APEX Aircraft Bureau de Navigabilité 1, route de Troyes 21121 DAROIS - France Tél +33 380 35 65 10 Fax +33 380 35 65 15 www.apex-aircraft.com	<h1>SERVICE BULLETIN</h1> <p>No. 020714</p>
HR200 – Assembly of the aileron rod on the bellcrank – replacement of the nut	
Supersedes : N/A

ATA : 271

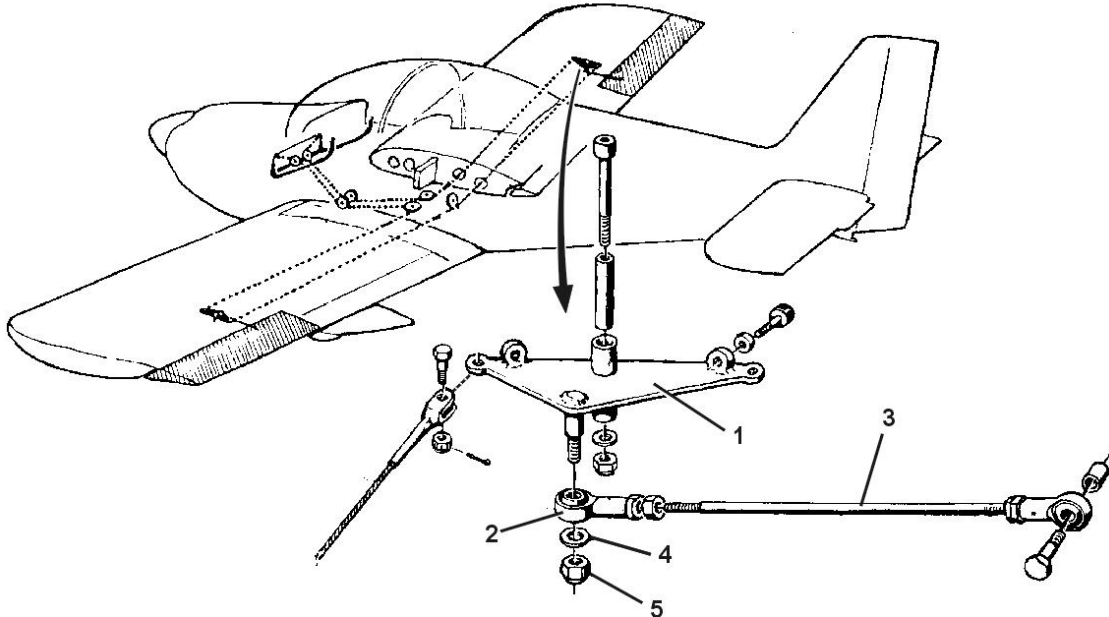
The aileron rod (item 3) is attached to the aileron bellcrank (item 1) by means of:

- a rod end bearing (item 2) ;
- a washer (item 4) ;
- and a nut (item 5).

The attachment using Askubal rod end bearing (mounting 2) does not allow enough safety screw threads coming out to properly lock the nut.

In case of not enough safety screw threads coming out, this SB recommends to install a thin nut 8TA10BE (and to remove the washer when mounting the Askubal rod end bearing).

- a) Measure the thickness of the rod end bearing. If the thickness is:
 - superior or equal to 12 mm (0.47 in) (Askubal rod end bearing), the washer is to be removed.
 - inferior to 12 mm (0.47 in) (Sarma rod end bearing), the washer is to be added.

- b) If necessary (§3a), put the washer in place.
- c) Replace Nylstop nut 8PA106 by nut 8TA10BE.
- d) Screw the nut and tighten moderately (1.2 to 1.5 daN.m) (106 to 133 lbf.in).
- e) Check the number of threads coming out from Nylstop nut. There must be a minimum of one thread and a half (1.5 thread).
- f) Check that the aileron control responds normally to the movements of the stick.

- a) Never install a washer.
- b) Always use a thin nut 8TA10BE.
